**City of Lancaster
Engleside Combined Sewer Rehabilitation**

**ADDENDUM NO. 3
2/21/20**

CITY OF LANCASTER
 LANCASTER COUNTY, PENNSYLVANIA
**ENGLISIDE COMBINED SEWER
 REHABILITATION**

MAINTENANCE OF FLOW PLAN

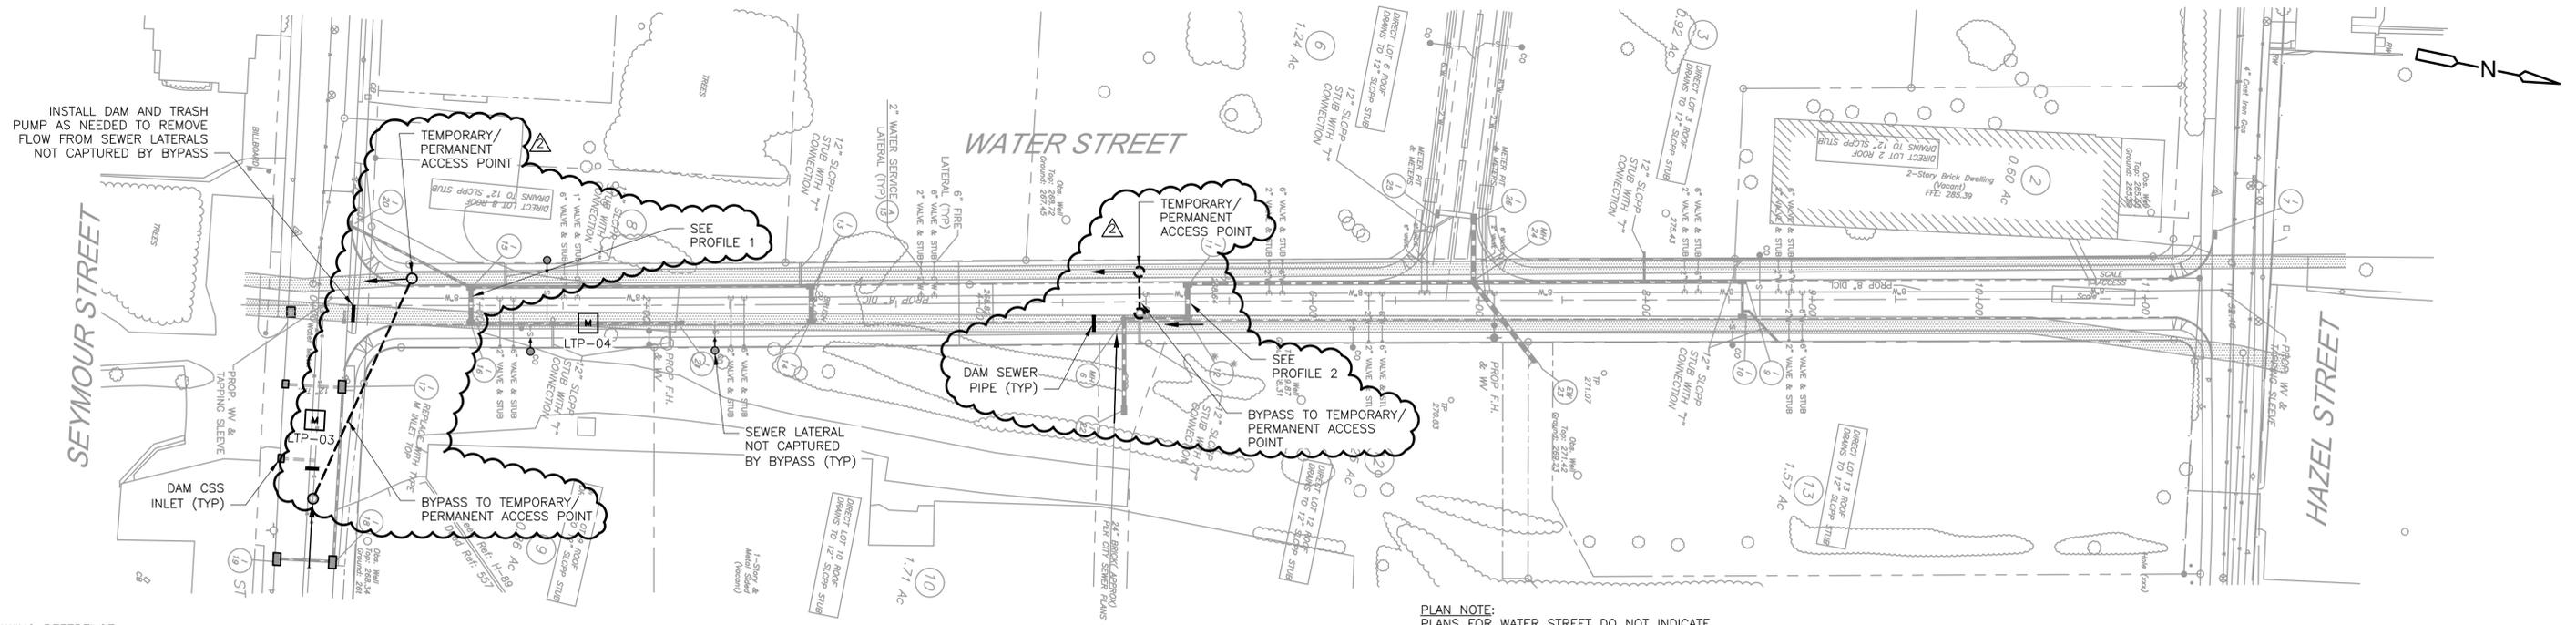
32. The arch pipe cannot technically be lined with CCCPL technology since the crown of the pipe and not the invert are scheduled to be lined. Can we hand apply (gunite) concrete in the arch pipe to cover the top of the pipe and not the invert?

Answer: Approved material can be applied in manners consistent with the respective manufacturer's recommendations. Gunite concrete will not be an acceptable material.

PROJECT NO. 20467-112244
 FILE NAME: CO02NFL.DWG
 SHEET NO.
C-2

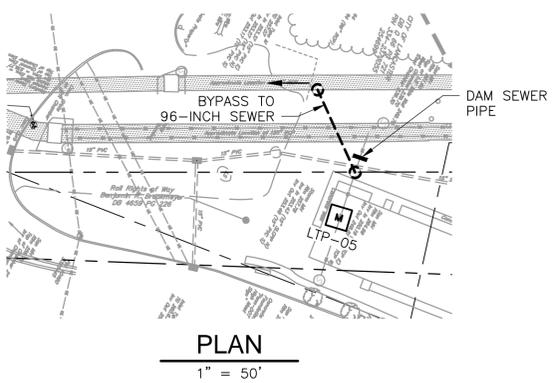
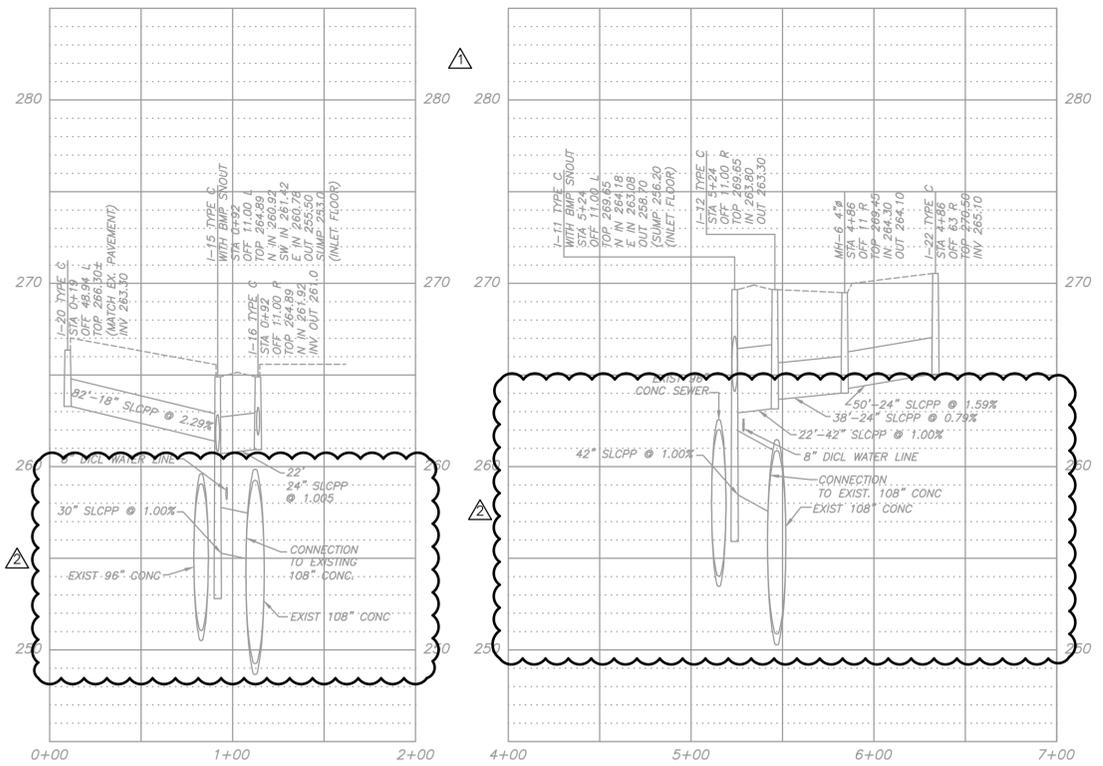
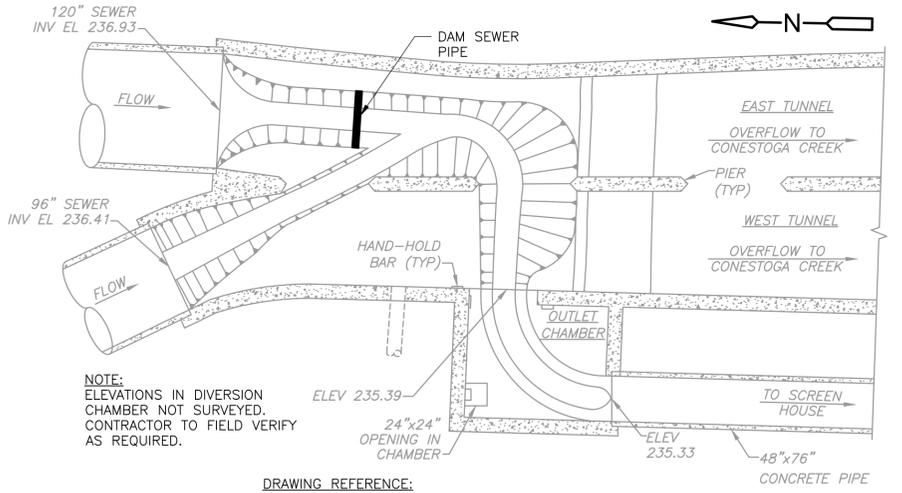
A. Drawing C-2 - Maintenance of Flow Plan

1. Based on a site inspection by the City of Lancaster, it was determined that the two stormwater inlets along Engleside identified to receive bypass flows are connected to the 108-in sewer instead of the 96-in sewer. Contractor will need to establish two temporary/permanent access points on the 96-in sewer to convey the bypass flows in this area.
2. Replace this drawing with the revised Drawing C-2 attached to this addendum.
